Woodward-Clyde Consultants

May 25, 1979

As you requested during our site visit to Milstone in support of the Dresden #2 seismic evaluation effort, I recommend that EGG perform the analysis of three piping systems, recirculation, LPCI suction and seismic example problem #1 identified as being typical of the three methods used to seismically qualified Dresden 2 piping systems. Specifically, I recommend the following analyses be

Response Spectrum Envelope, Mass (This curve replotted from original

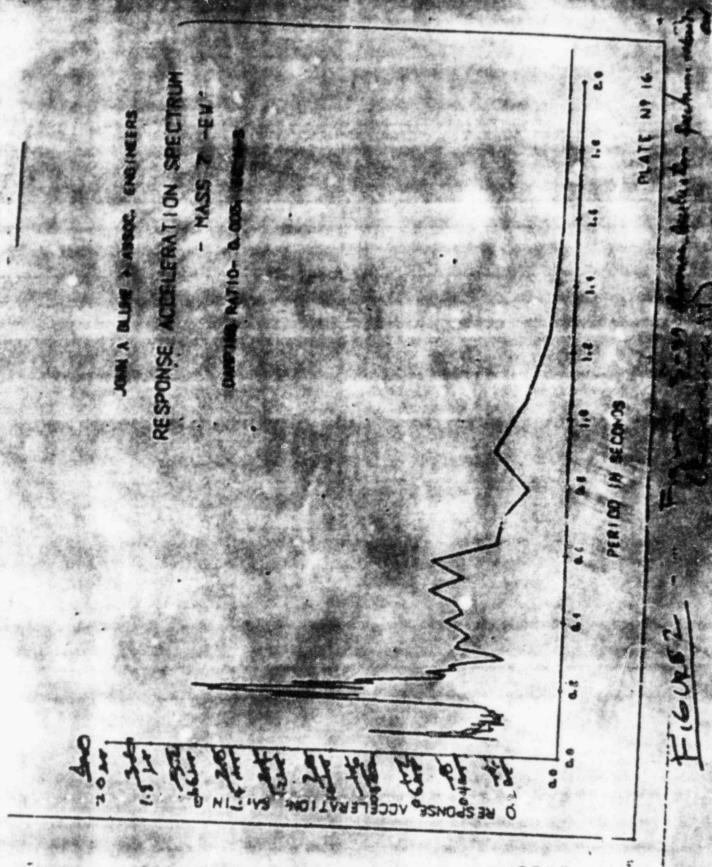
- 1. Analyze system using best estimate of support stiffness and analysis methods with seismic input from the J. Blume response spectral curves shown in Figure 1 assumed acting first in the nominal N-S and then in the E-W horizontal directions plus 2/3 this spectrum in the vertical direction. Moment resultants are to be combined on both the SRSS and ABS bases. Resultant seismic stresses to be compared to J. Blume resultant seismic stresses at at least 3 common points. Seismic reaction forces in supports should also be determined and compared to J. Blume results if available. Stress intensification factors of NC 3600 should be used. This effort has essentially been 'ready completed in the summary report by M. E. Nitzel exer t that the response spectra used as shown in Fig. 1 has been smoothed and broadened somewhat from the original Blume curves shown in Fig. 2 and the response spectra has been normalized to a 0.2g ZPGA rather than 0.1g OBE ZPGA which was used by Blume. The purpose of this analysis is to evaluate the adequacy and accuracy of the original Blume analysis which is also applicable to steam and feedwater systems.
